**Re: GE-Pittsfield/Housatonic River Site
Upper ½-Mile Reach Removal Action (GECD800)
Revised Contingency Plan for NAPL Remaining in Cell G2**

GENERAL ELECTRIC COMPANY
PITTSFIELD, MASSACHUSETTS
REMOVAL ACTION
UPPER 1/2-MILE REACH OF HOUSATONIC RIVER
MODIFIED RESTORATION
CROSS-SECTION C-C'
(NAPL CONTINGENCY)

SECTION C-C'

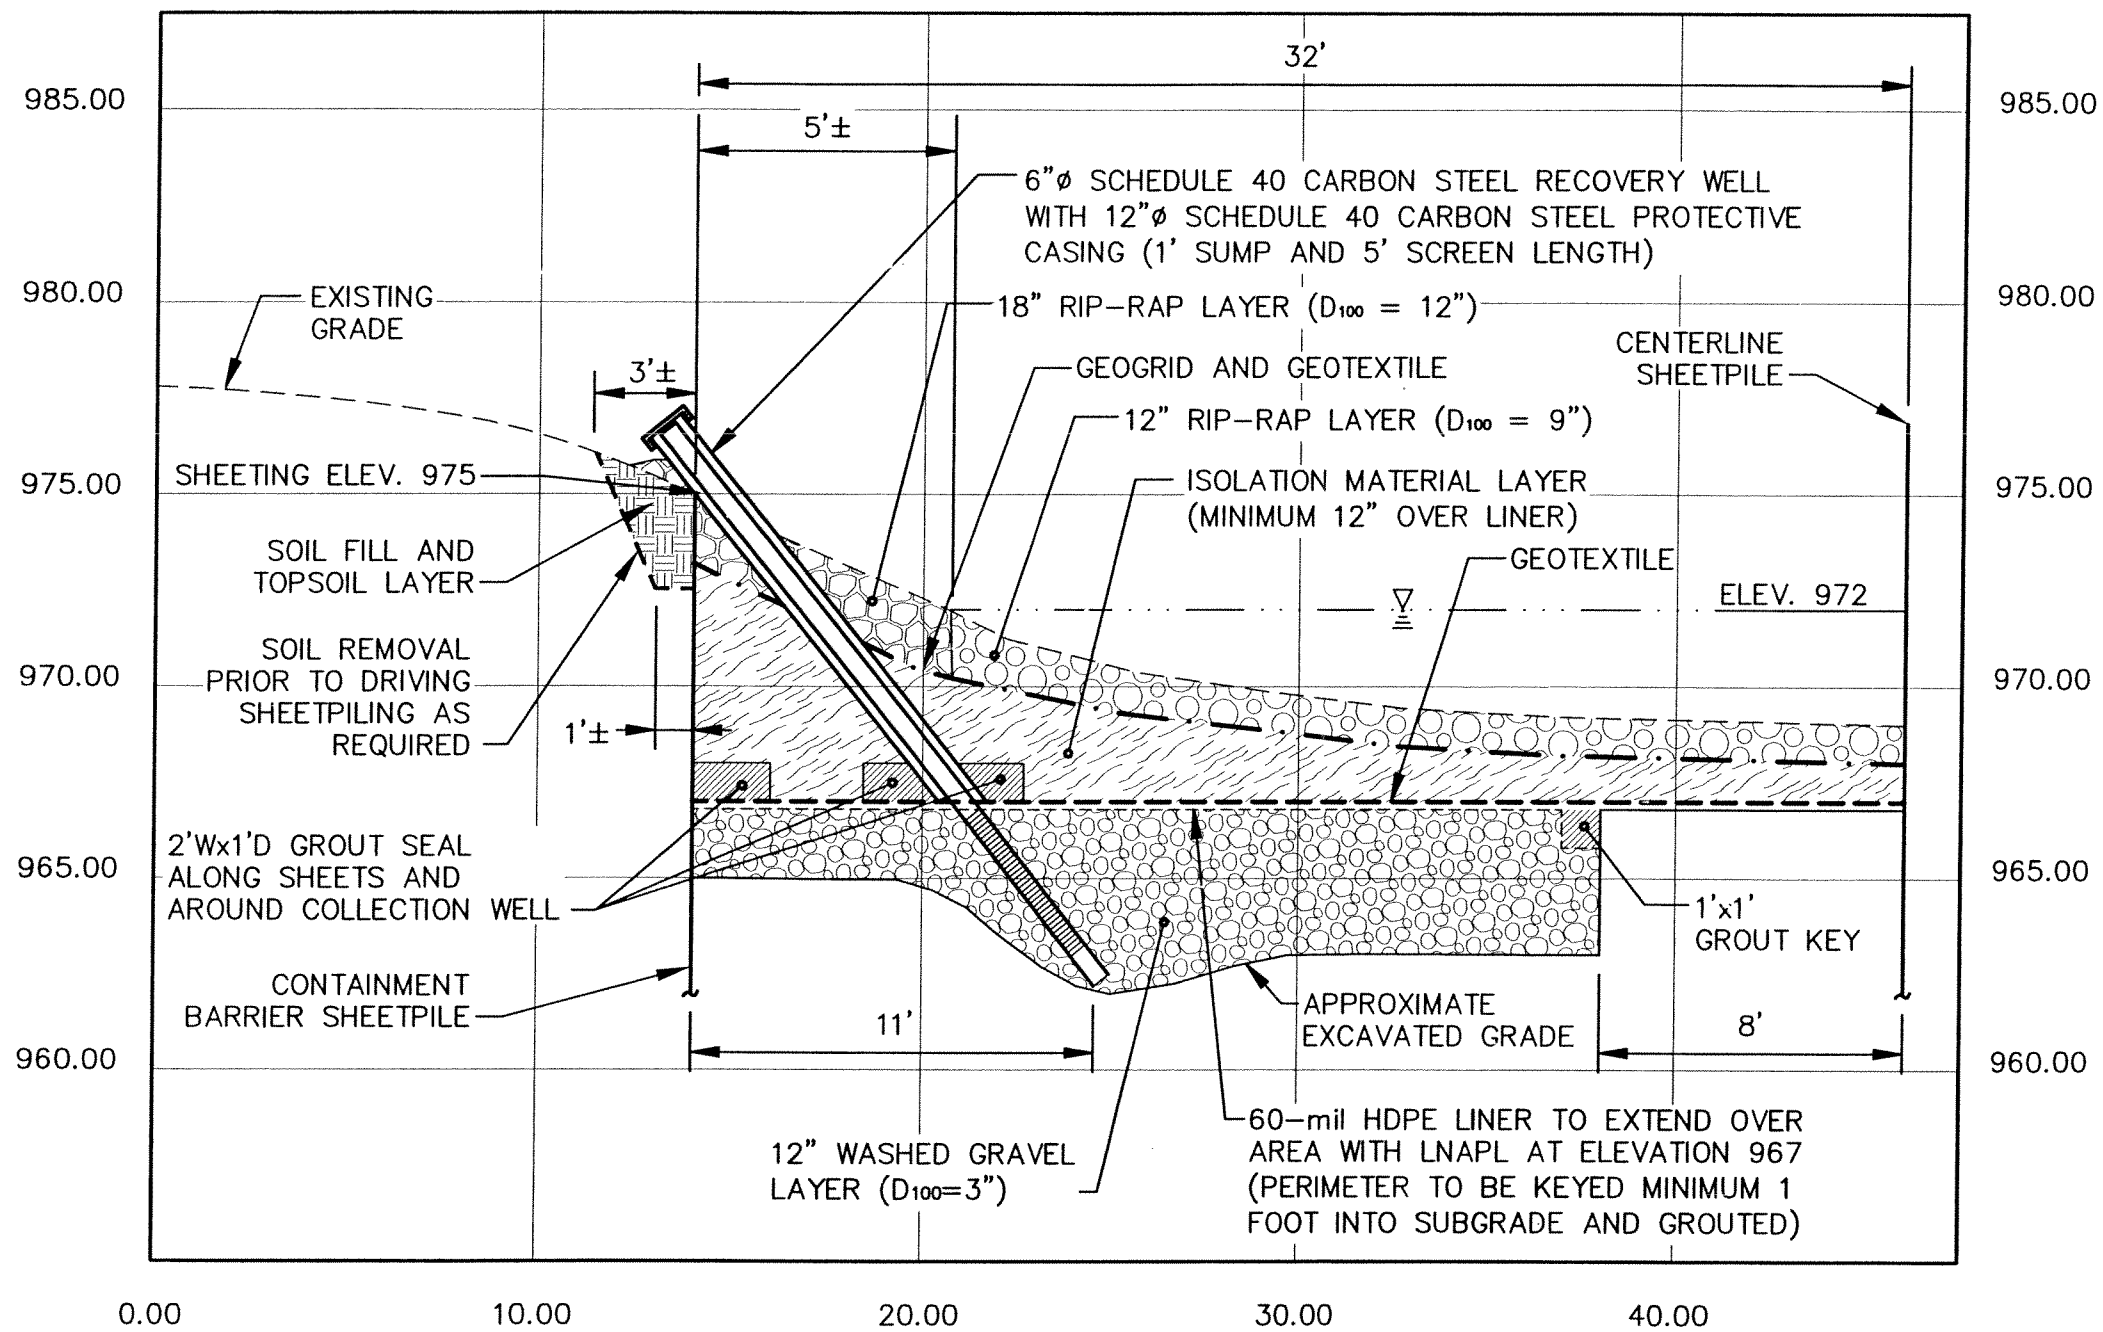
The primary modifications include installing the collection well at an angle to the low point of the NAPL excavation area, filling the entire NAPL excavation area with gravel, and constructing the geomembrane layer at elevation 967 feet (see Figure 1). To accommodate this new configuration, the observation/recovery well will include a one-foot sump and a five-foot length of 0.090-slotted screen. Isolation layer material will be placed above the geomembrane and the remainder of the area will be restored in accordance with the provisions set forth in the Upper ½-Mile Reach Removal Action Work Plan (BBL, August 1999).
